Subject: RE: 23/02254 FUL The Rancher, Manor Farm Lane, Tidmarsh, Reading RG8 8EX

Arboricultural Report
BS5837:2021 (Trees in Relation to Design, Demolition & Construction)

Client: Manor Farm Tidmarsh Ltd.
Site: The Rancher, Manor Farm Lane, Reading, RG8 8EX.
Date of survey: August 07th 2023
Date of report: September 15th 2023
Surveyor: Jon Harper cert.Arb (RFS)
Report reference: 2023053 v2.0

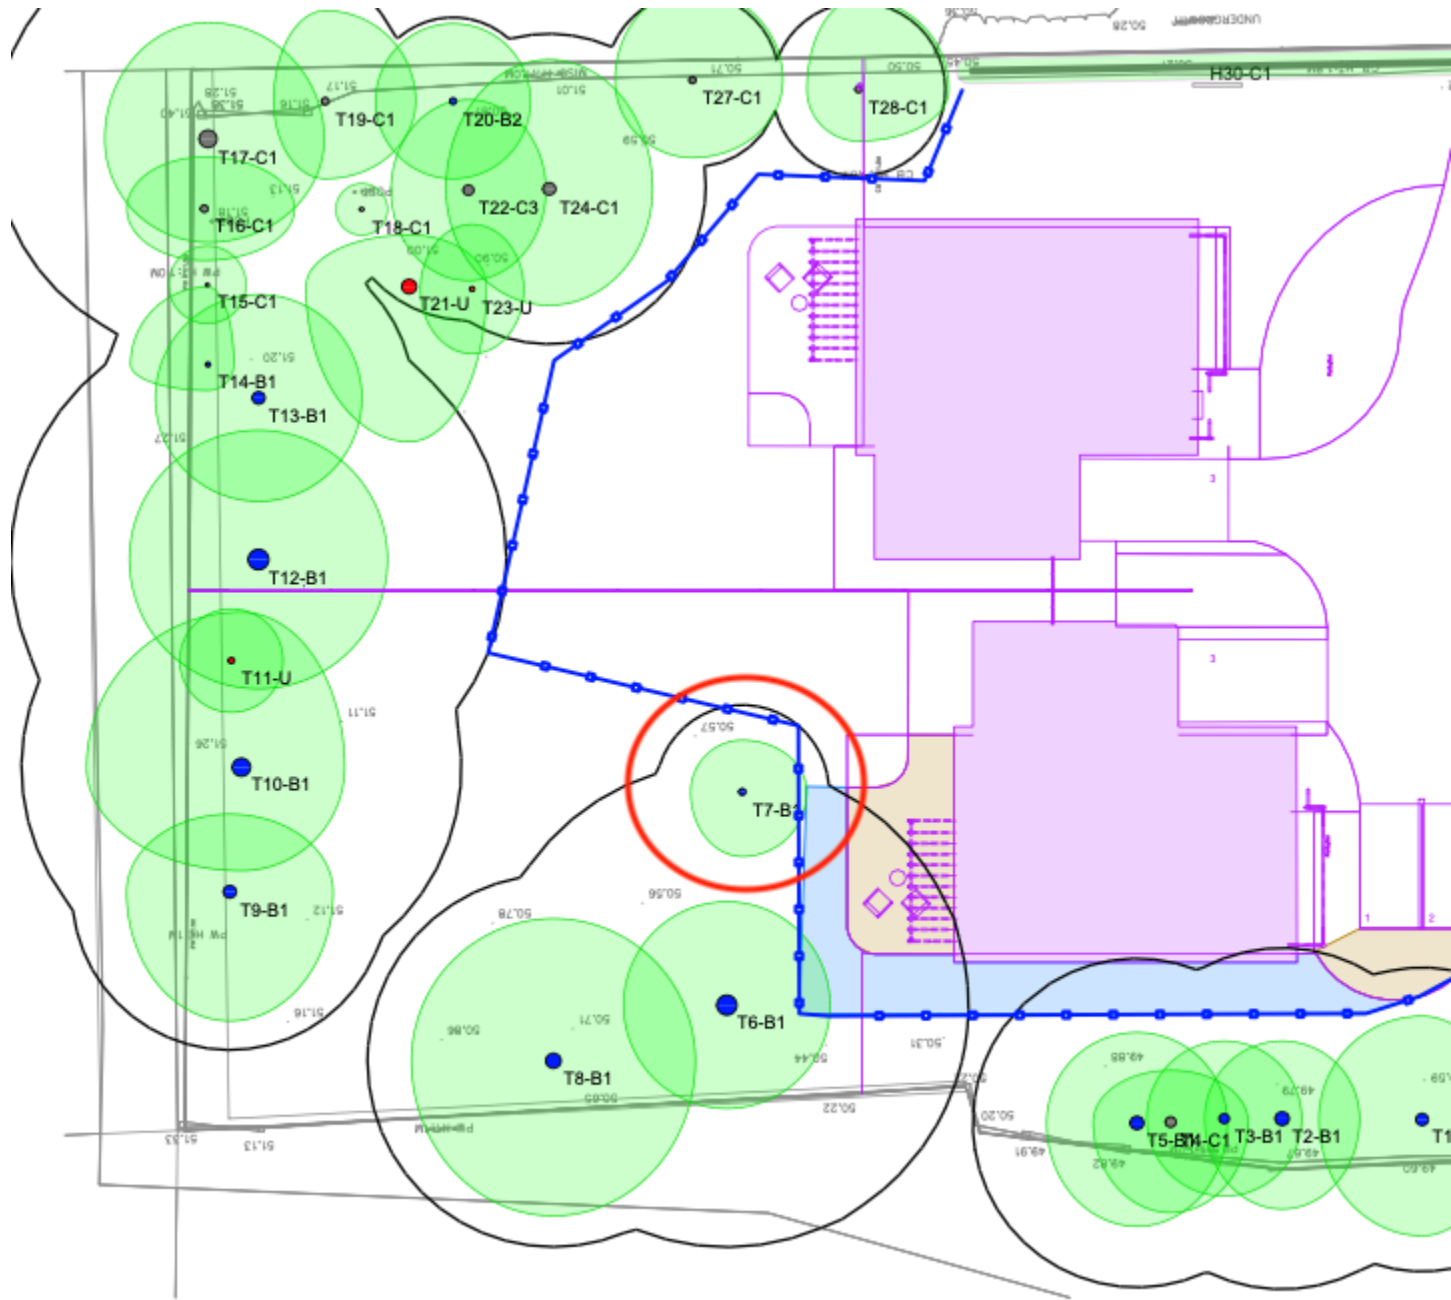
Please also see below a marked snapshot of the plan showing the Monkey Puzzle Tree. It is T7.

Client: Manor Farm Tidmarsh Ltd.	Date: August 07th 2023
Site: The Rancher	Ref: 2023053/TPP001
	Scale @ A3: 1:250
	Title: Tree Protection Plan

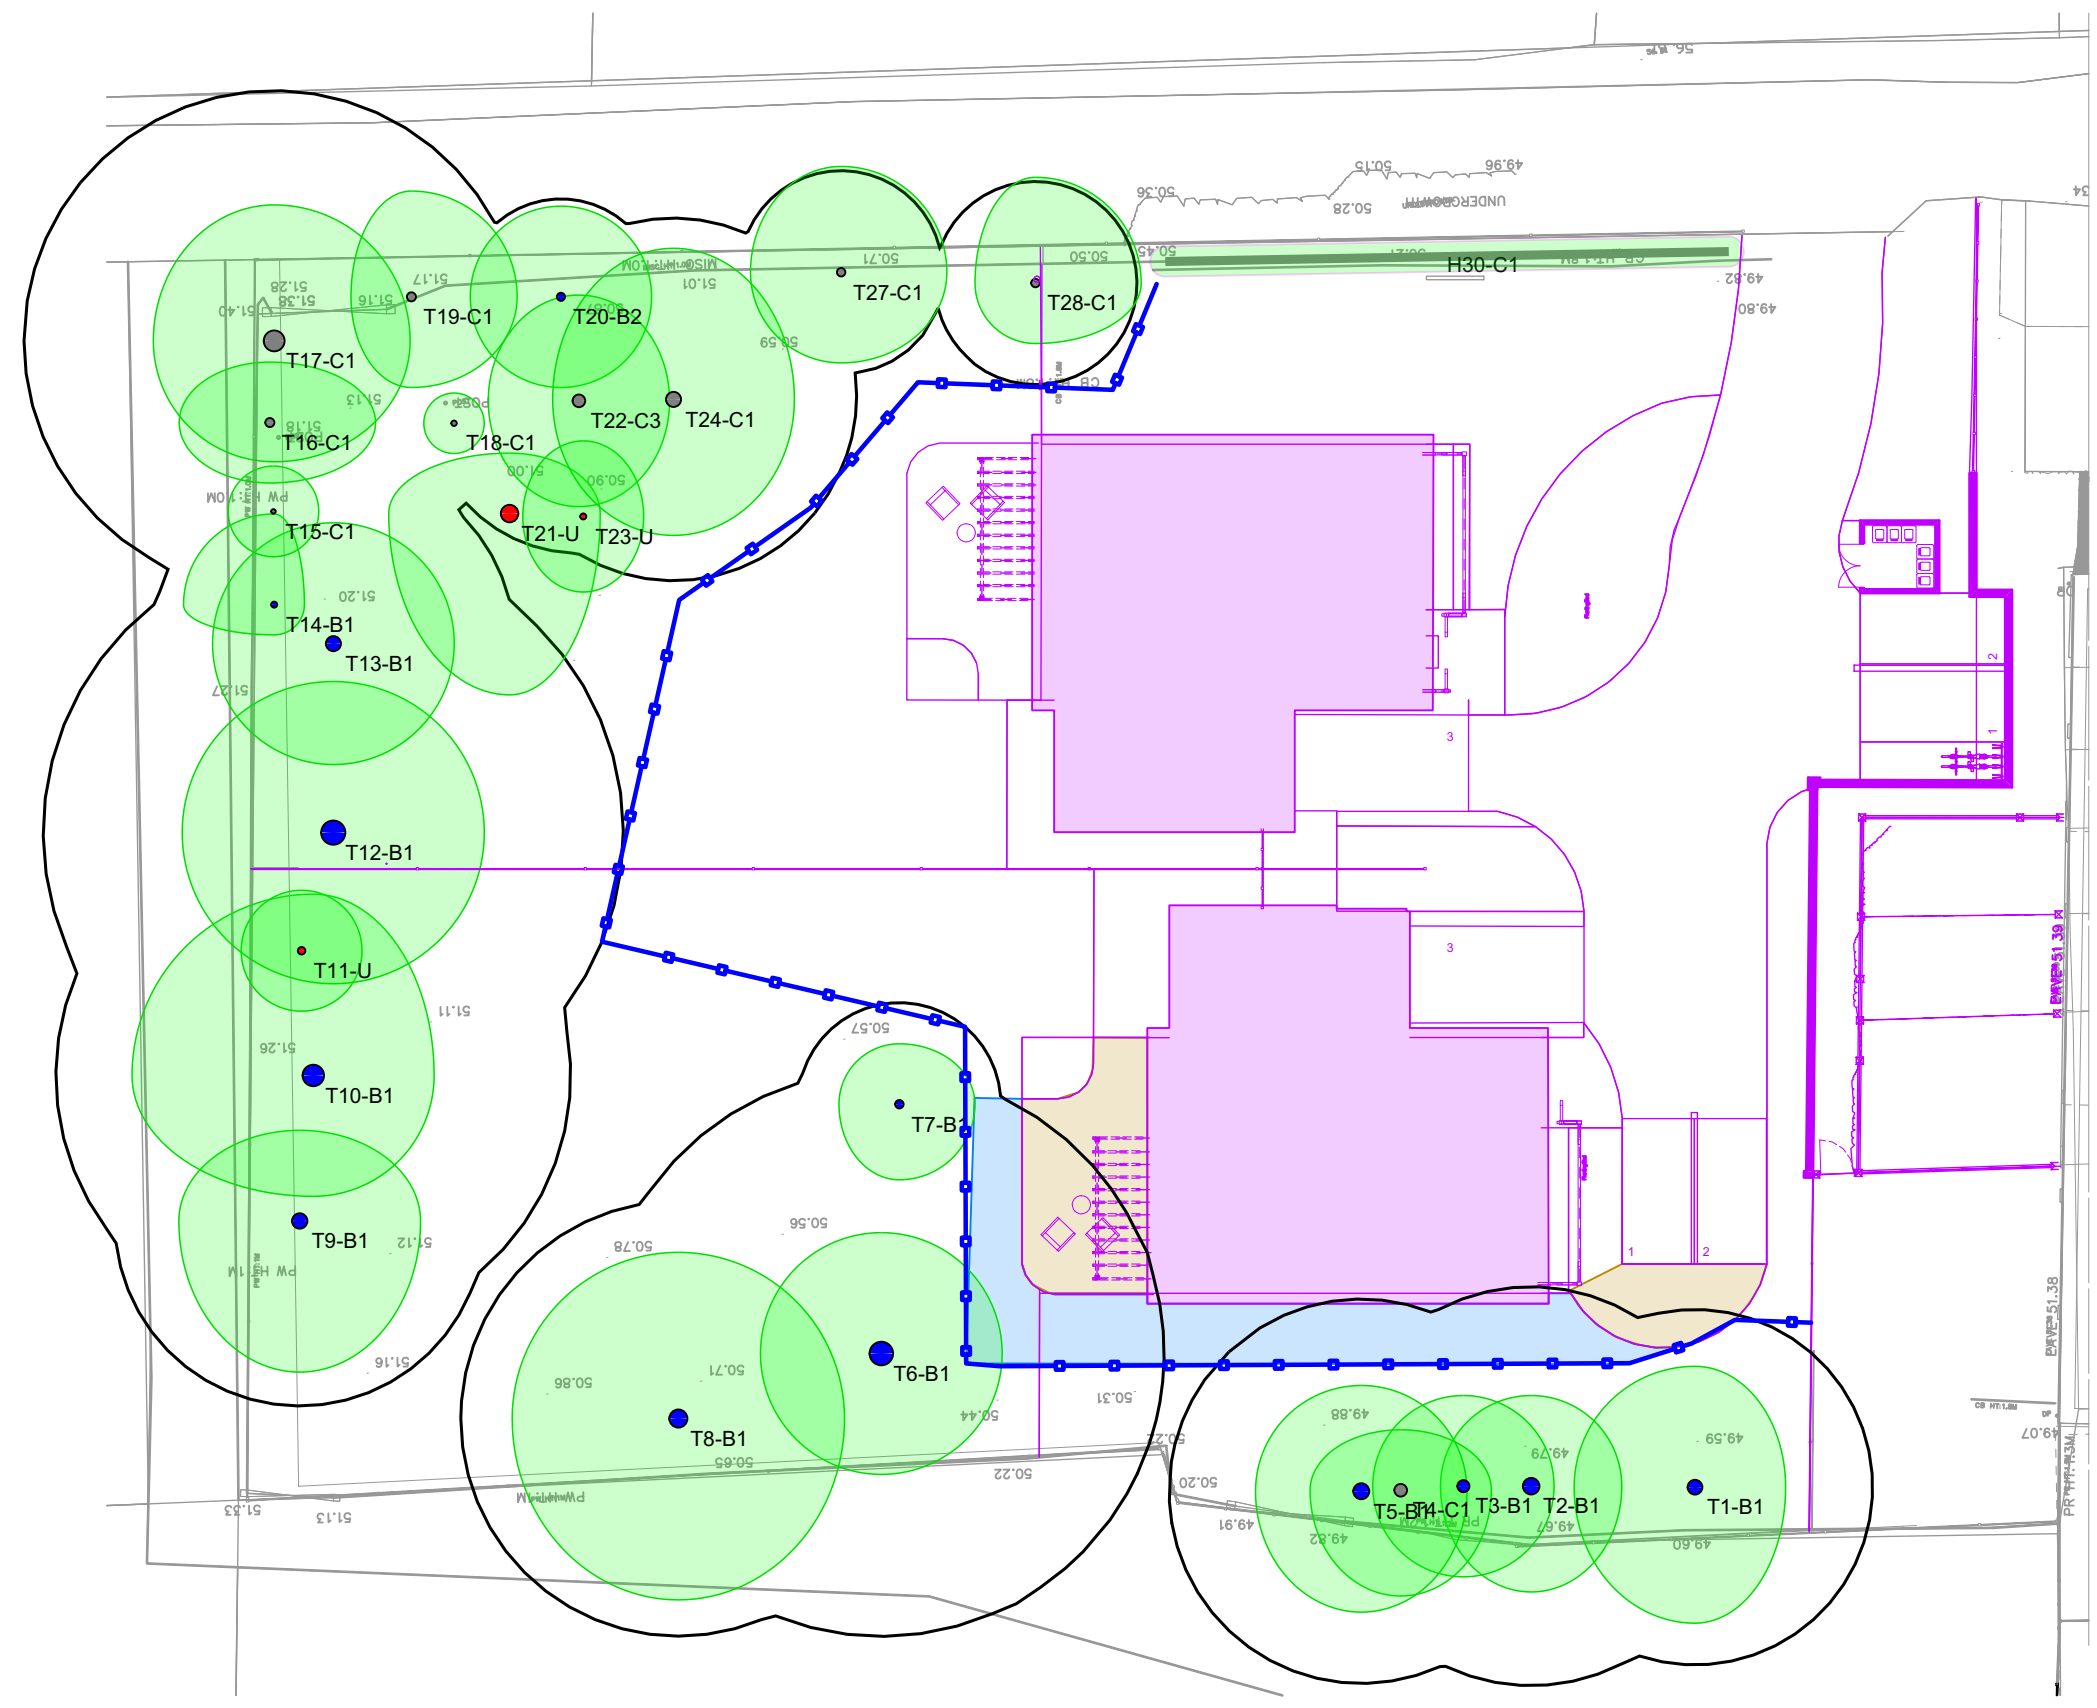
The application is for the demolition and replacement of the existing dwelling at the Rancher, with two new buildings. The application is accompanied by an Arboricultural Report to BS 5837:2012 by Harper Consulting. This includes an Arb Method Statement and Tree Protection Plan. The plan omits to show a reasonable Monkey Puzzle tree north of the location of tree T8 Larch. It is not clear whether this tree would be removed in order to accommodate the proposed development. It does seem to be located in the amenity area (implying it should be retained), however it would require protection from site activity and should be included in the TPP.

My site visit showed that fairly extensive groundwork has recently been undertaken immediately west and south of the site, resulting in the laying down of a large area of hardstanding south of the recently built houses of 23/02253 and a new surfaced access track to the fields west of this site. This is composed of recycled material including fines, but also concrete clasts of approx. 100mm. It has been laid in the root protection areas of trees to the west and probably those to the south, as well. So the Arb Report will need to be updated to reflect this change, which may impact the RPAs plus advise on any remediation needed. This may have impacts on the proposed layout – especially the proximity of the southern building to the Pine trees of TPO 314.

Upon investigation I have seen the request for amendments has been made. Please see report attached with a updates section in relation to why the RPA'S of T1-T5 do not need to be modified.

The word pre-existing is important in the context of trees numbered T1 - T5 in this instance. This is because there is a hard core track that was laid just to the south of those trees that was laid with consent in 2023. This track is permeable in nature and could not be considered to be a pre-existing structure as the trees are much older. Because of this, the root growth will be under the track and in line with the British Standard recommendations, the RPAs do not require modification.
